APPLICATION FOR CERTIFICATE OF APPROPRIATENESS

1028 Luttrell St. 37917

Staff Report

File Number: 9-F-24-HZ

Rear Exterior Elevation

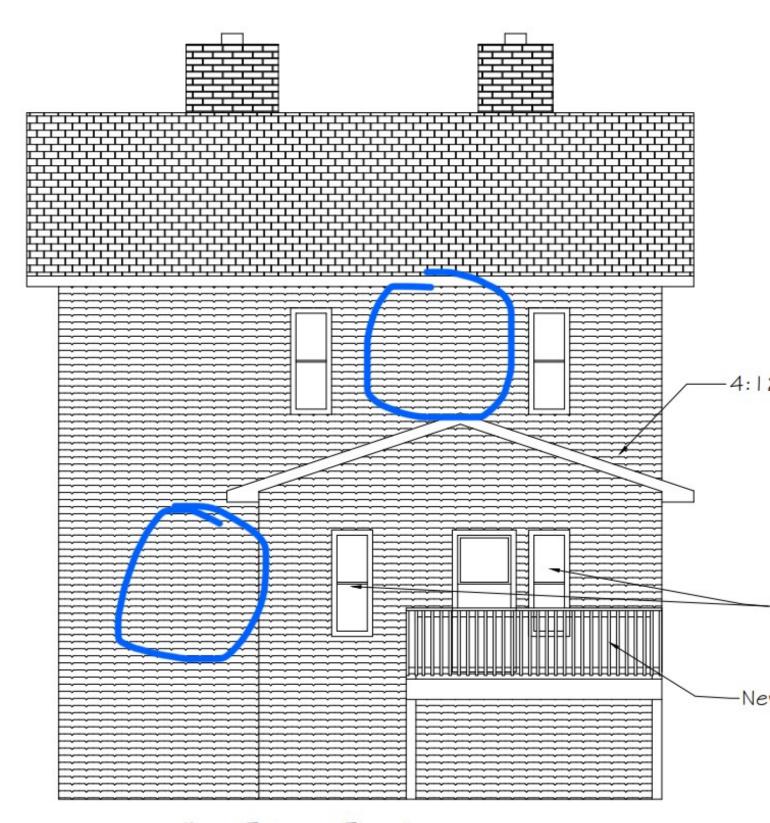
- 1. 1028 Luttrell Street is a contributing resource to the Fourth and Gill NR district and the local overlay. The house has experienced a significant amount of deferred maintenance, leading to deteriorated windows, foundation, siding, and roofing.
- 2. The rear addition to be removed is a non-historic enclosed porch, resting on a deteriorated, non-code compliant foundation, of which the City Plans Review and Inspections would not permit rehabilitation. Demolition of the rear addition is appropriate.
- 3. The new one-story, gable-roof rear addition is proportionate and secondary in massing to the primary house. On the left side elevation, the addition will extend approximately 17' from the main massing of the house, an additional 10' from the existing rear addition. Due to the adjacent vacant lot, the left elevation of the addition will be visible

from the right of way. The addition should receive one window to contribute additional transparency to a large swath of siding.

- 5. The two windows proposed to be removed are located on the rear elevation and will not be visible from the right-of-way due to the new addition. Removal of these windows is appropriate.

- 1) left side of rear addition to receive one window for additional transparency;
- 2) exterior window trim to be repaired and/or replaced in-kind;
- 3) new fiber cement shingles to match existing asbestos shingles in size, thickness, and detail, with measurements provided to staff;
- 4) new porch flooring to use tongue-and-groove wood instead of decking;
- 5) front porch railing detail to be submitted to staff for review.
